UNITED STATES PATENT AND TRADEMARK OFFICE

APPLICATION NO.	FILING DATE	FIRST NAMED INVENTOR	ATTORNEY DOCKET NO.	CONFIRMATION NO.
10/560,569	12/12/2005	Hiroki Ito	81880.0134	6663

Office Action Summary

DETAILED ACTION

Reproduced from JP. Pub. 10-332988.

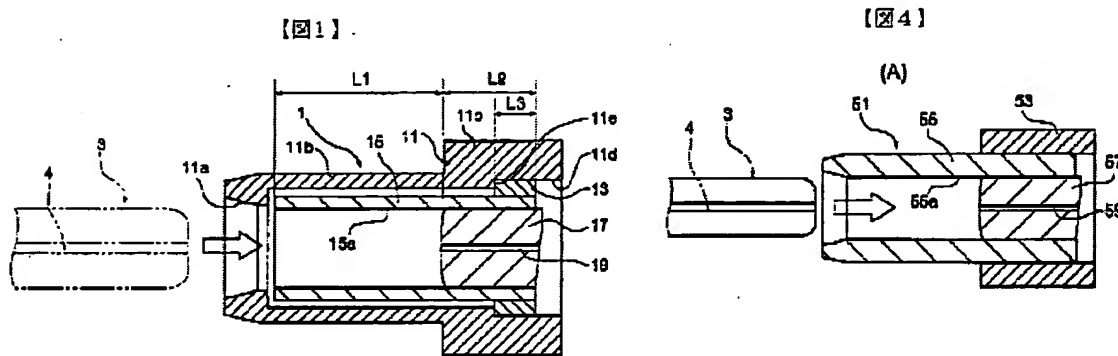
Regarding claims 1-3, Ishida Chisako anticipates an optical receptacle device comprising the following:

- a fiber stub having ferrule 57 and optical fiber 59 inserted in the ferrule through-hole 57 ([0002], Fig. 4).
- a holder 53 holds to fix the rear end of the fiber stub ([0002], Fig. 4).
- an elastic sleeve 15 having 15a inner hole for ferrule 17 inserted in the end face side of the sleeve and the front face side is for holding a plug ferrule 3 ([0008], Fig. 1).
- a gripping/grasping ring or hold ring 13 is inserted/covered the outer periphery of the base end part of the fiber stub or the elastic sleeve 15 (abstract, Fig. 1, [0007]).
- the hold ring 13 or grip ring is fixed to the holes 11d ([0010]).
- the hold ring 13 or grip ring is made of plastic ([0009]), which “controls the elastic elongation/contraction of the base end part of the elastic sleeve 15, which

anticipate the claimed of the grip ring is an elastic body” of the present invention (abstract, [0009]).

Reproduce from US. Pub. 2004/0076384.

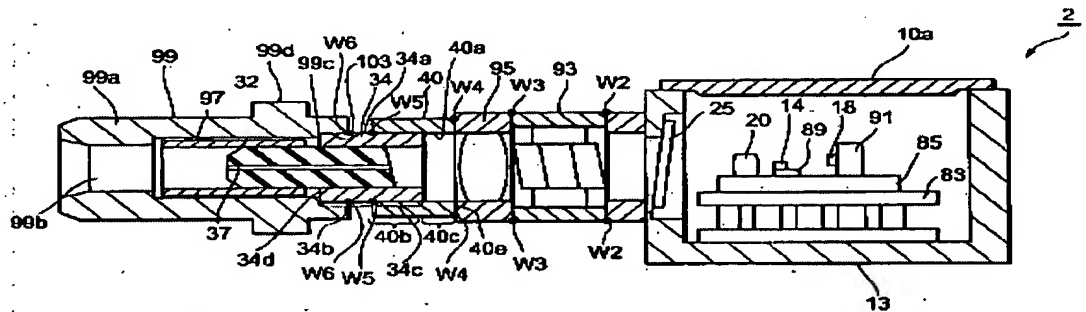
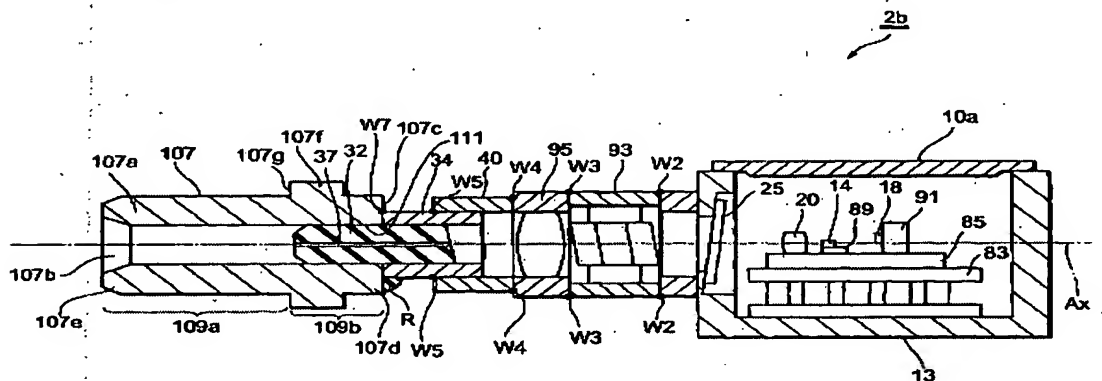
Regarding claims 9, 11, Kato et al. disclose the claimed invention such as:

- a ceramic precision sleeve 107 is made of ceramic material, for holding a plug ferrule ([0094], [0095], Fig. 11A, and Fig. 13). As known in the art, the ceramic is an electrical insulation material.
- a metal holder 34 is provided at a rear end of the precision sleeve 107 (“Abstract”, Fig. 11A, and Fig. 13).
- a flange/protruding portion 107f is formed by integrating with the ceramic precision sleeve 107 (Fig. 13) or the flange/protruding portion 99d “...provided on the outer surface of the side wall 99a” of the precision sleeve 99 ([0086], Fig. 11A). With integrating designed as mentioned above, the flange/protruding portion is electrically insulated from the metal holder 34.

Regarding claim 13, Kato et al. disclose claimed invention such as a ceramic ferrule 32 of the same material as the precision sleeve 107, and an optical fiber 37 is inserted in the hole 36 of the ferrule 32 ([Fig. 13, [0047]]). In additional, the ceramic ferrule 32 is inserted into the ceramic precision sleeve 107 ([0089]).

Kato et al. fail to teach that the flange is a separate or moveable from the precision sleeve.

It would have obvious to one having ordinary skill in the art at the time the invention was made to form the precision sleeve and the flange/protruding portion together integrally in one piece with same material of ceramic, since the optical module can facilitate the optical alignment and the sleeve secures a part of the holder to position the holder relative to the body as

Fig.1

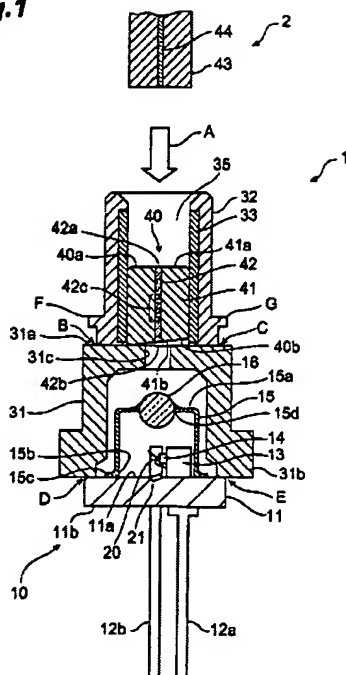
Yamabayashi et al. disclose flange/protruding F, and G are provided on the outside face of the precision/outer sleeve 32 (Fig 1, col. 7, 46-47), wherein the tier portion and the spacer are formed integrally with the flange/protruding in one piece (Fig. 1).

It would have been obvious to one having ordinary skill in the art at the time the invention was made to modify **Kato et al.** by using the teachings of **Yamabayashi et al.** to provide the electrical insulated ceramic precision sleeve formed integrally with flange/protruding, tier portion, and spacer, and also in order to help the optical plug 2 connected to the plug ferrule easily (Fig. 1, col. 7, 45-49).
